HISTORIC AND DESIGN REVIEW COMMISSION

HDRC CASE NO: 2017-584

ADDRESS: 525 MADISON ST

APPLICANT: Nathan Manfred/French & Michigan
OWNER: Edward H Slezak Caroline Matthews
TYPE OF WORK: Construction of a rear accessory structure

A200

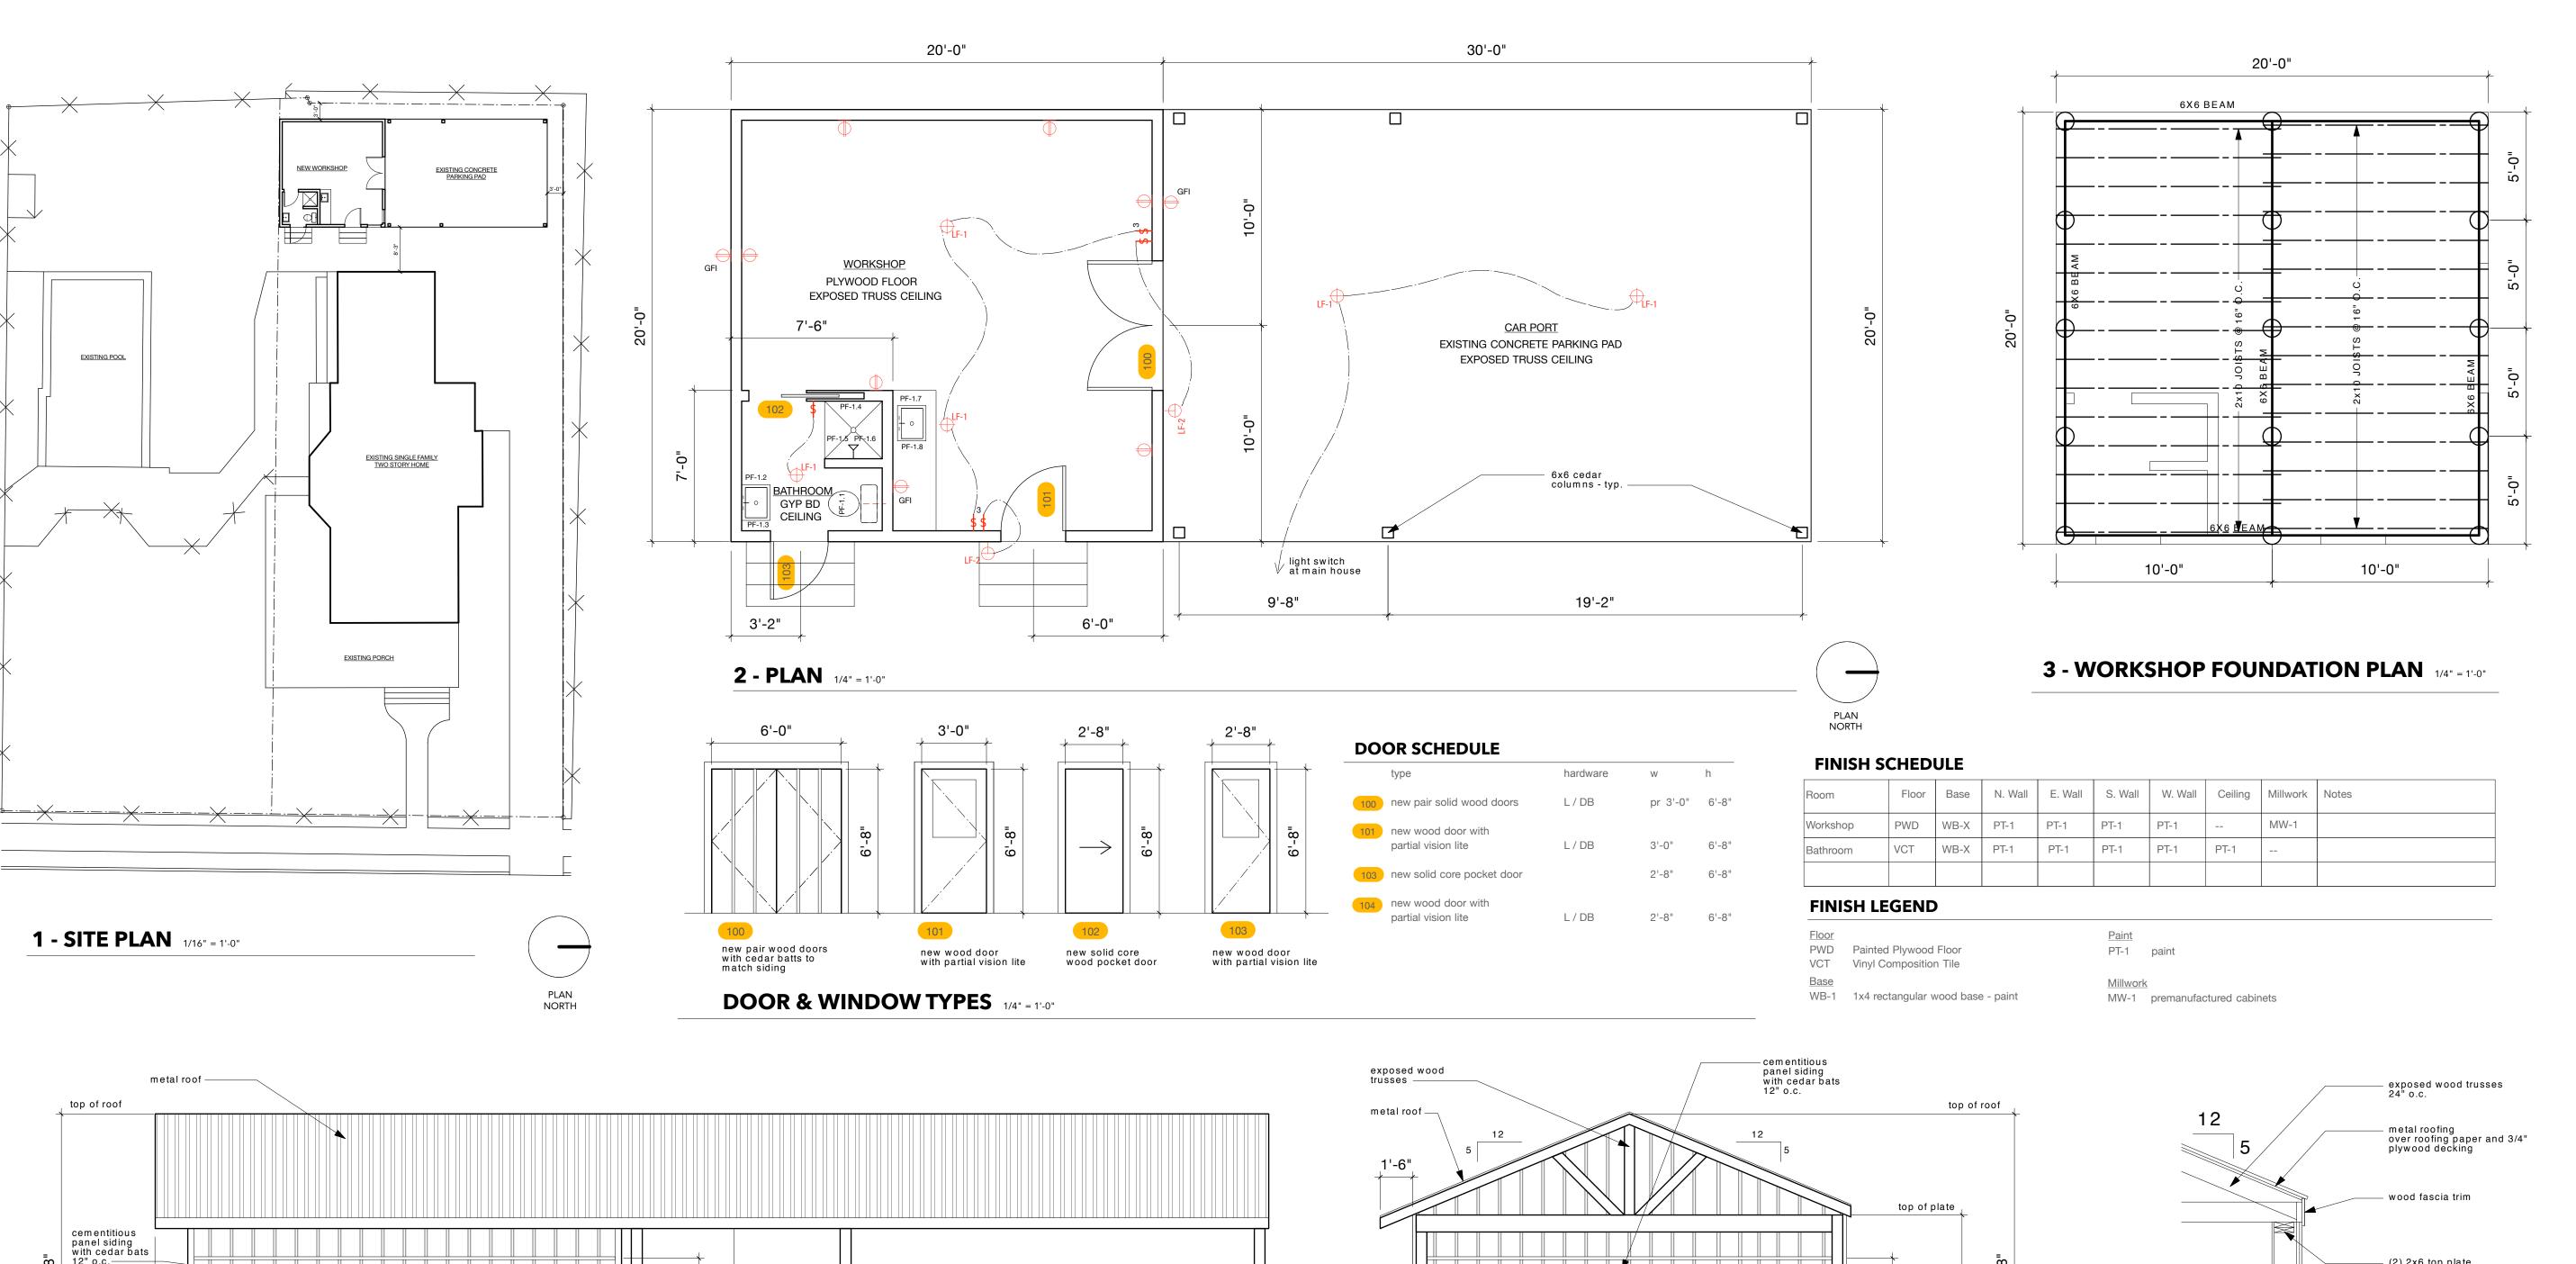
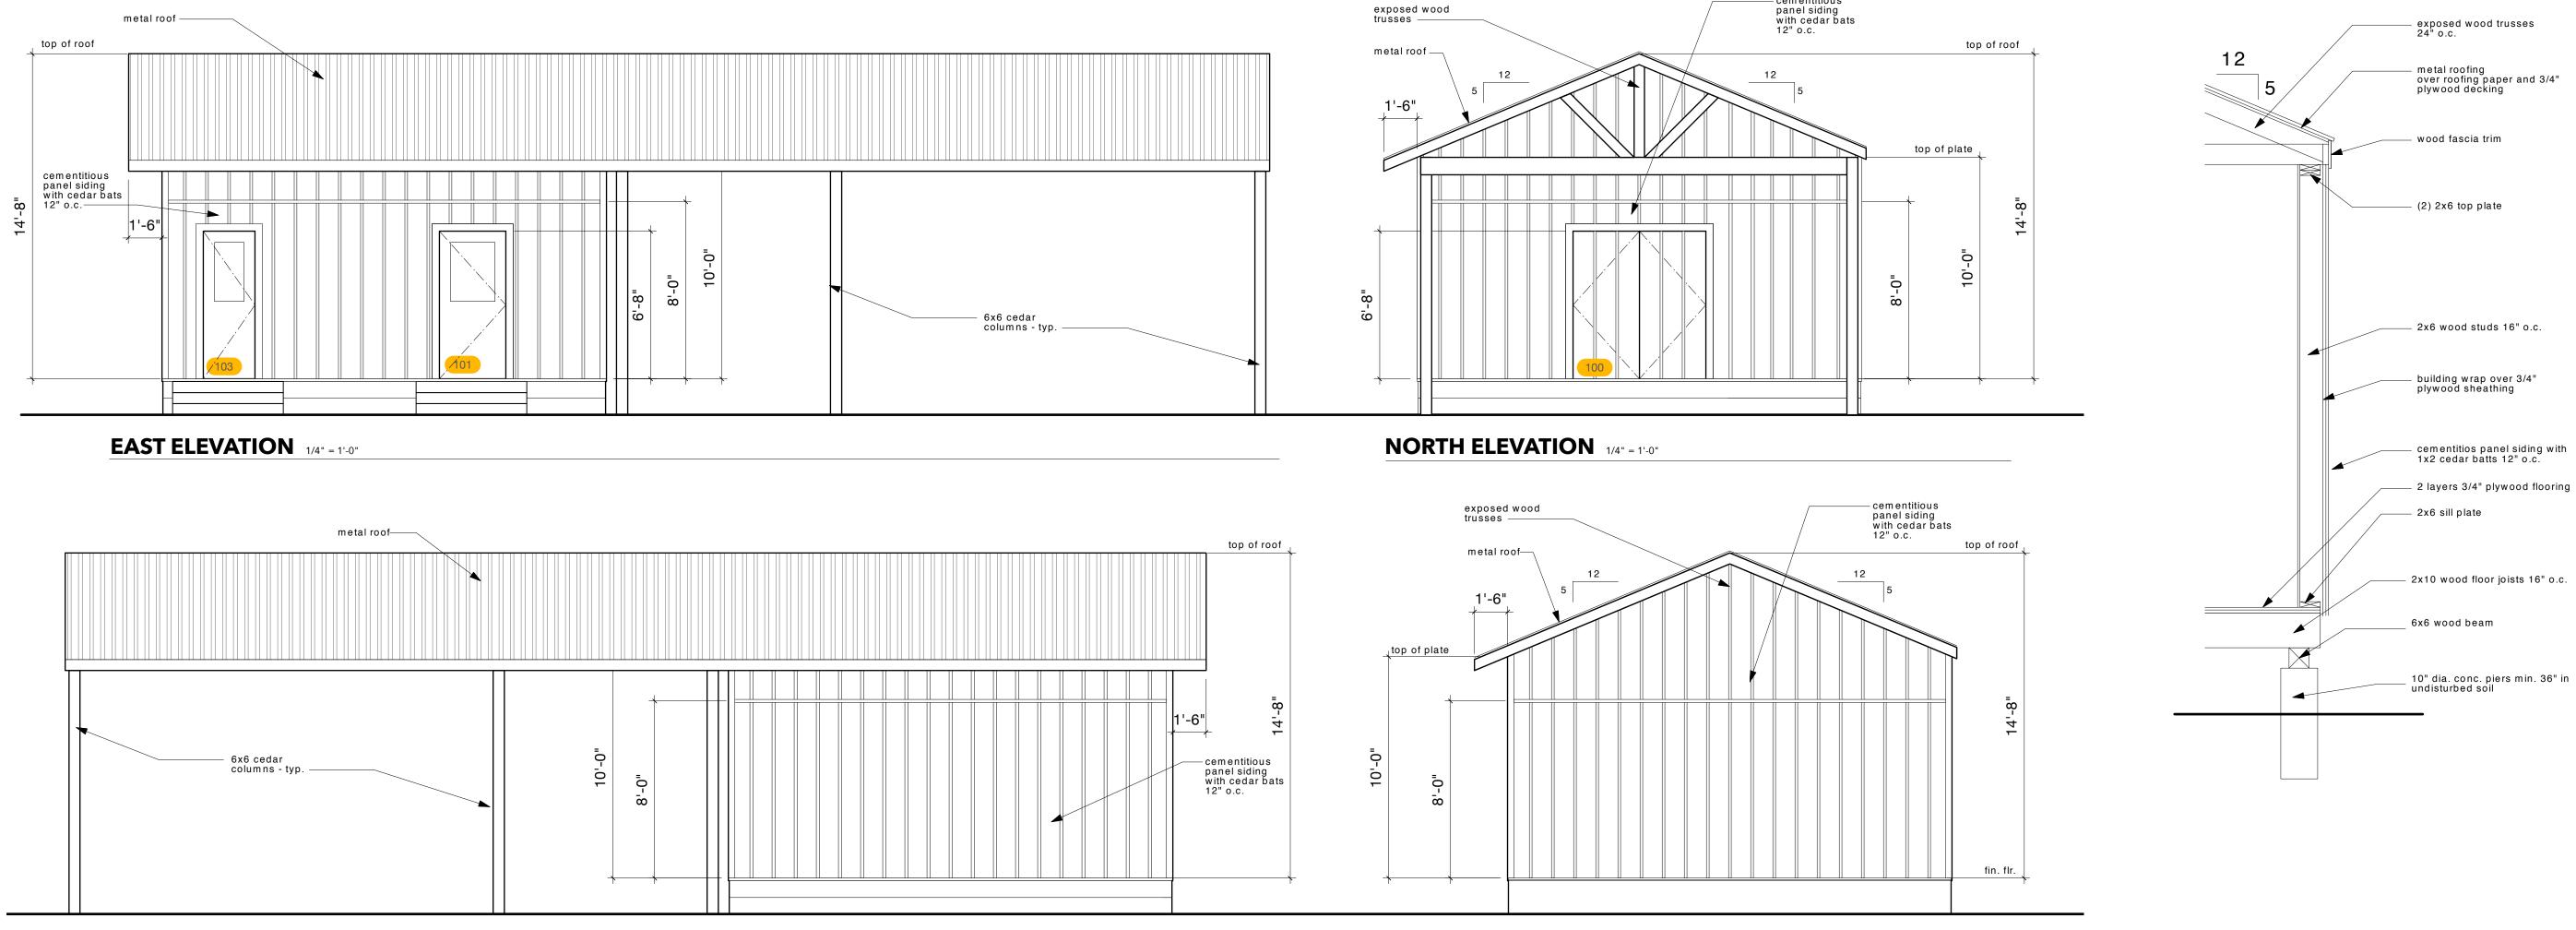
- e. NEW CONSTRUCTION The applicant has proposed for the structure to feature an overall height of 14' 8", an overall footprint of 1,000 square feet with 400 square feet being the enclosed accessory structure, side gabled roofs, board and batten siding, a corrugated roof and wood doors. Generally, the proposed new construction is consistent with the Guidelines. The proposed carport will feature a footprint of 600 square feet; however, the structure will be open air and will be constructed over an existing concrete slab. Staff finds that given the openness of the carport, the structure will not be visually obtrusive the rear yard.

- i. That either a 5v crimp or a standing seam metal roof be installed in place of the proposed corrugated metal roof. 18 to 21 inch wide panels, 1 to 2 inch tall seams and a crimped ridge seam are to be used for a standing seam metal roof.
- ii. That all historic wood from the existing structure be salvaged and reused where possible.
- iii. That the proposed board and batten siding feature boards that are twelve (12) inches wide with battens that are $1 \frac{1}{2}$ wide.
